CELL TOWER
(62 GRANITE SPRINGS ROAD)
QUESTIONS AND ANSWERS

Questions were asked by members of the Town Board; answers were given by Bob Wilson, resident, who used his engineering experience in the wireless and radio communications fields to address each question.

Excerpt from Figure 3: Current Predicted Coverage

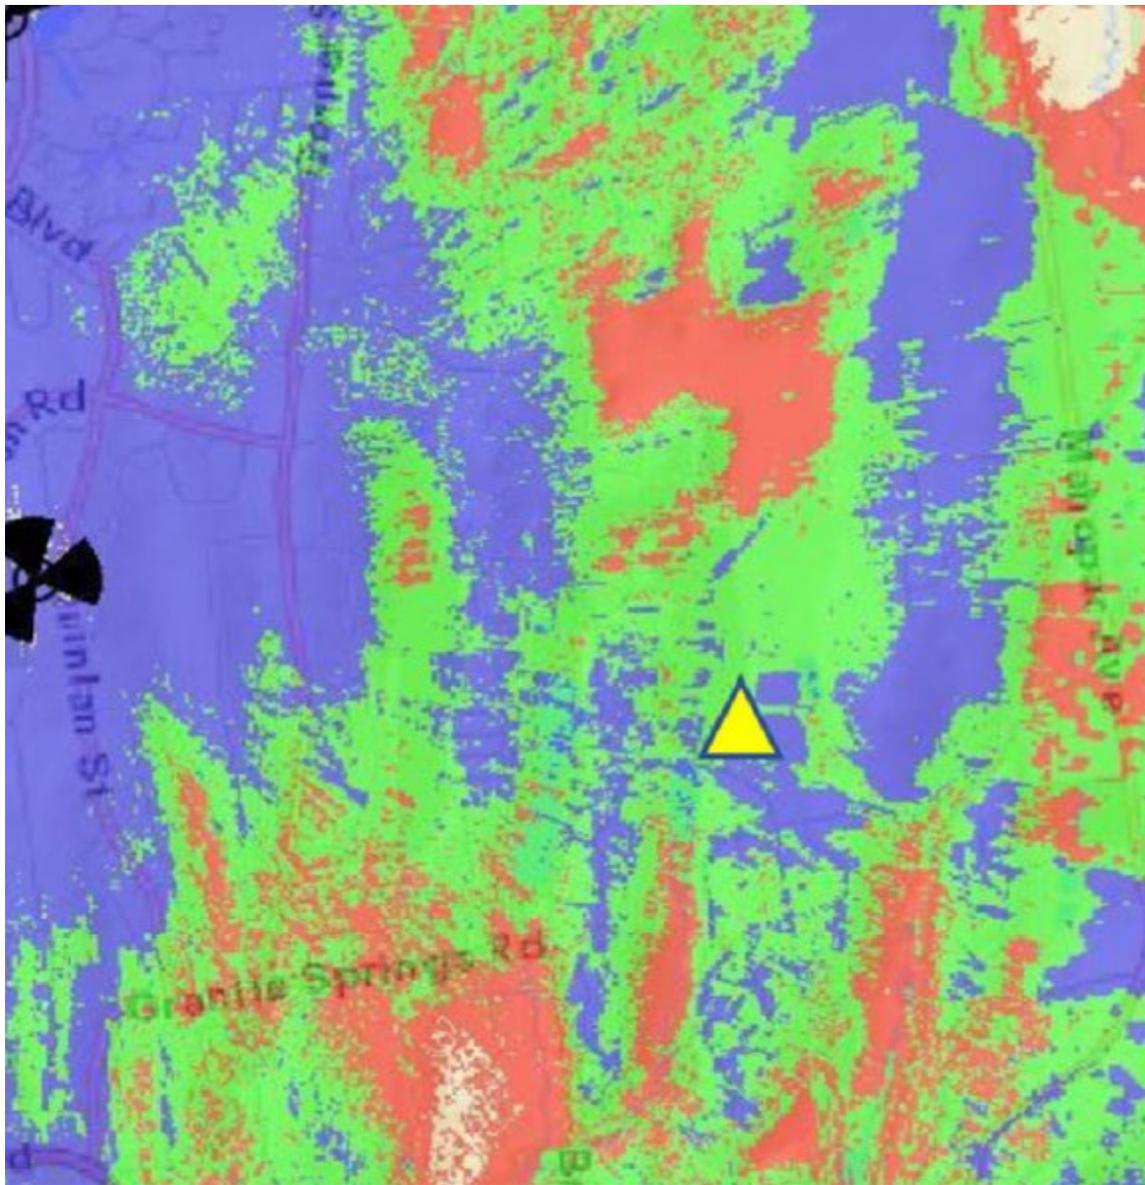
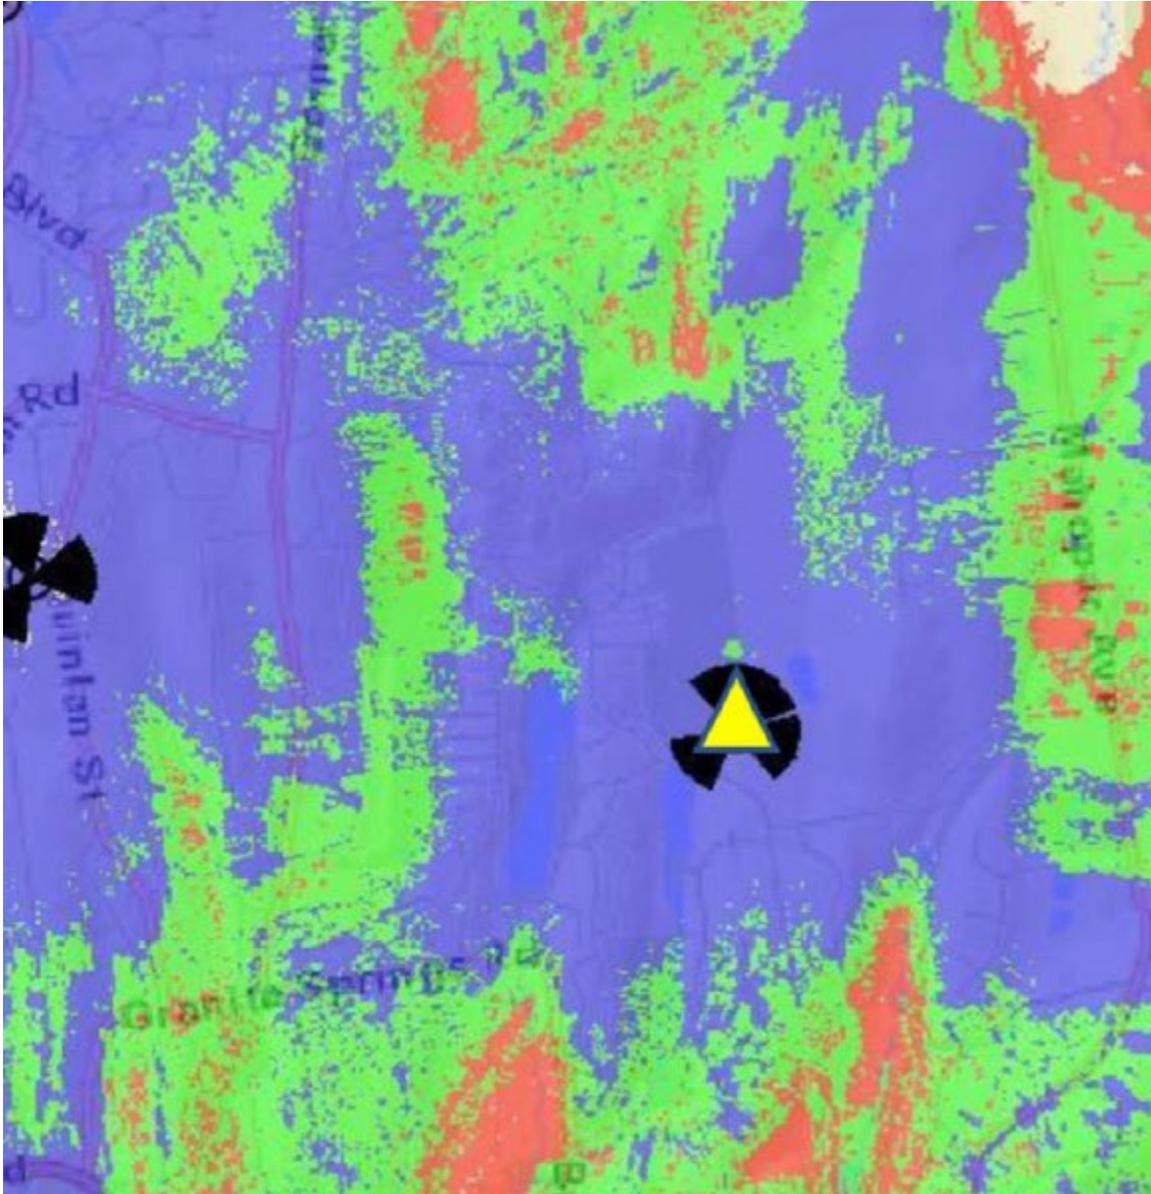
The RF coverage maps submitted by V-COMM are predictive models created using standard industry software. These maps are based on assumed inputs such as terrain, surrounding vegetation and buildings, antenna configuration, and selected signal strength thresholds. While this type of modeling is commonly used in the wireless industry, it is based on assumptions and is not be given the same weight as actual drive test measurements taken in the field.

To quantify the modeled coverage improvement, I reviewed the approximately 2-by-2 mile area depicted in Figure 3 (existing coverage) and compared it to the same geographic area shown in Figure 5 (proposed coverage). Using pixel-based analysis software to evaluate the colored signal classifications within the defined improvement zone, I compared the relative proportions of weak, moderate, and strong predicted signal coverage.

Within the evaluated area, the modeled weak-signal (red) coverage decreases by approximately 59% with the proposed tower in place. Using a simple scoring method that assigns values to weak, moderate, and strong signal areas, the overall predicted signal quality improves by approximately 10%. Although the red (weak signal) area drops by about 59%, it was only a small part of the total area to begin with, so when looking at the entire 2 × 2 mile area, the overall signal quality increases by about 10%.

While the modeled results demonstrate a measurable improvement in predicted coverage, they do not, by themselves, establish the existence or severity of a significant coverage gap without supporting empirical performance data from a drive test.

Also important to consider is whether the modeled weak-signal (red) areas correspond to occupied structures, residential neighborhoods, commercial areas, or primary road corridors, as opposed to predominantly wooded ridge lines, reservoir areas, or generally low-population terrain. The practical significance of a modeled coverage gap depends not only on its size, but also on where it occurs.

For completeness of the Town's review of the proposal, the Town should request that Vcomm provide a formal quantified comparison of existing versus proposed conditions using its own modeling data, expressed in terms of percentage reduction in weak-signal area and, and if desired a weighted signal-quality index. In addition, the coverage exhibits would benefit from clearly depicting structures and roadways to allow evaluation of whether the modeled deficiencies occur in areas where service demand is reasonably expected.
